RE: Jolly Pit, Permit No. M-2012-010, Amendment (AM1), Incompleteness Notice No. 2

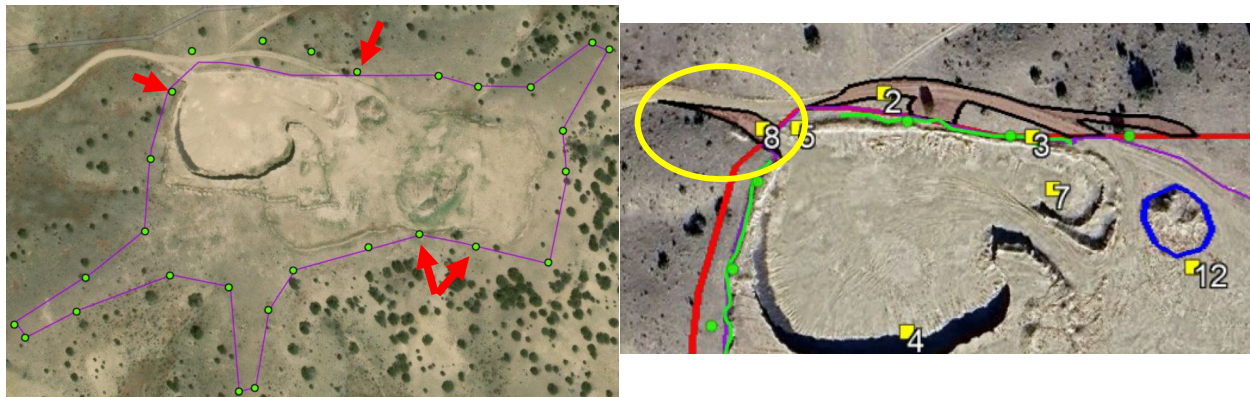
2. Part of the corrective actions required to abate violation no. MV-2025-002 is to submit an amendment application to update the approved mining and reclamation plans to account for all of the affected land. The "Display C-d affected land" map submitted with the responses to the Division's first incompleteness notice includes some of the affected land identified within the inspection report for the Division's November 5, 2024 inspection. However, an area on the west side of the entrance to the pit was excluded (see Figure 1 below). Please revise the boundary to include all of the affected areas identified during the 2024 inspection and resubmit the maps.

3. Figure 1 also highlights where a few of the current markers are extremely close to the current disturbance onsite. The Applicant may want to consider also relocating these markers through this amendment application to help prevent future accidental offsite disturbances.
